From: Waters, David [David.Waters@pgnmail.com]
Sent: Monday, July 02, 2012 3:56 PM
To: Habib, Donald
Subject: NRC Letter 108 Draft Response - Pages 1-44
Attachments: NRC Letter 108 RAI L-0998 Response - Draft 07-02-12_Part1.pdf

| [NRC Letter 108 RAI \(Seismic Hazards\) Dated March 15, 2012](#)

| [Progress Energy Response L-0998 to NRC RAI:](#)

**Levy Nuclear Plant Units 1 and 2
COL Application
Part 2, Final Safety Analysis Report**

Revised Figure 2.5.2-294: Horizontal 10⁻⁵ UHRS, GMRS, and Scaled GMRS Based on CAV for the LNP Site.

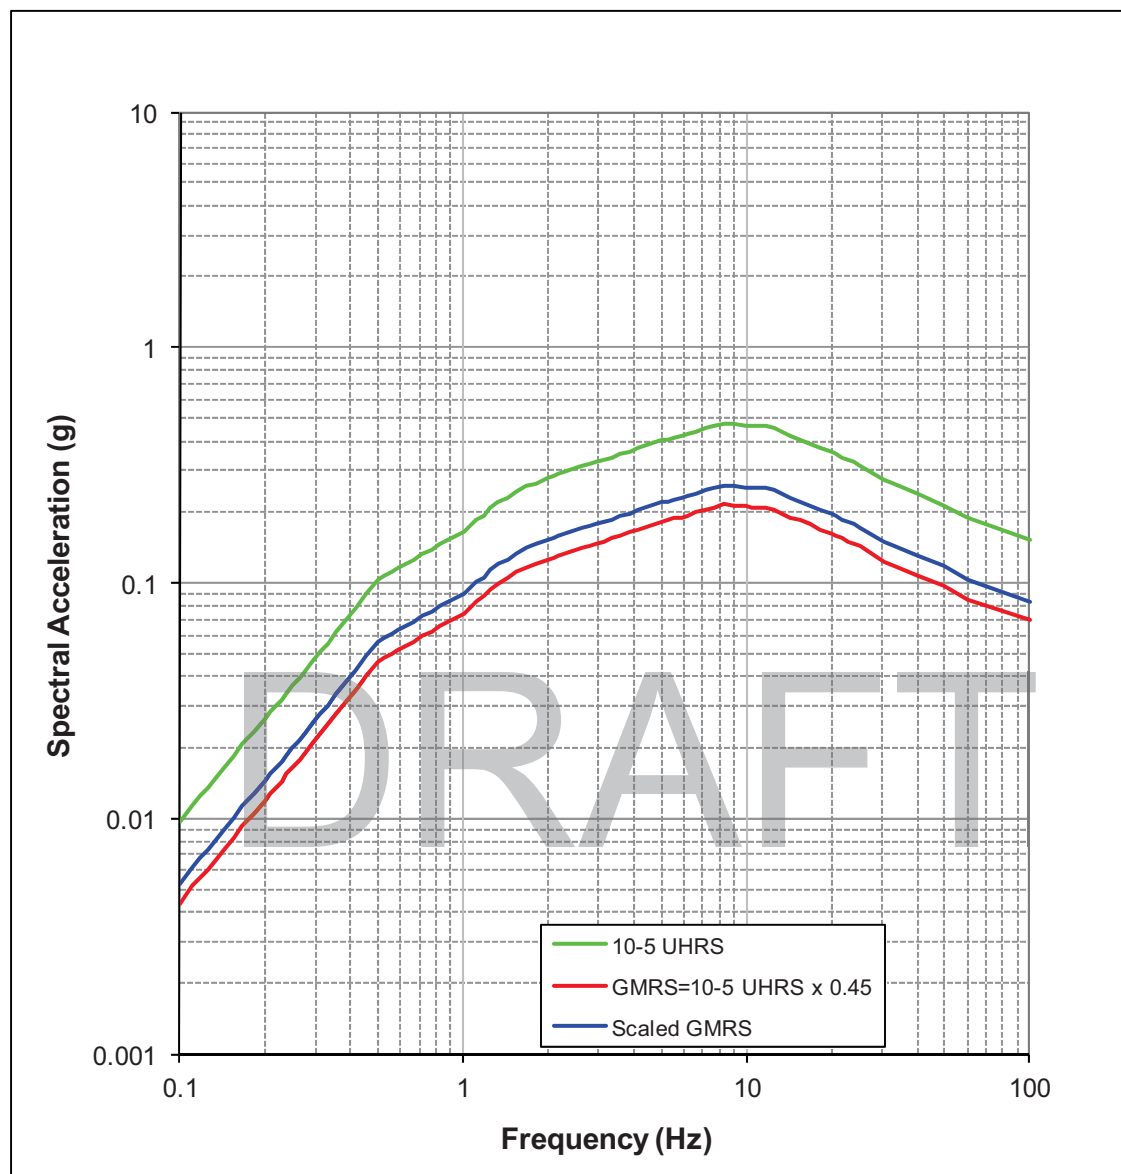
- Revised Figure 2.5.2-294: Horizontal 10-5 UHRS, GMRS, and Scaled GMRS Based on CAV for the LNP Site.
- Revised Figure 2.5.2-296: Horizontal and Vertical Scaled GMRS for the LNP Site

Regulatory Guide 1.208 also specifies that when the value of A_R exceeds 4.2, the amplitude of the GMRS is to be no less than $0.45 \times SA(0.1H_D)$ that is, 45 percent of the 10^{-5} UHRS. As the 10^{-4} UHRS with CAV is 0, this second criteria is used to define the horizontal GMRS. Figure 2.5.2-294 shows the horizontal GMRS calculated as $0.45 \times SA(0.1H_D)$.
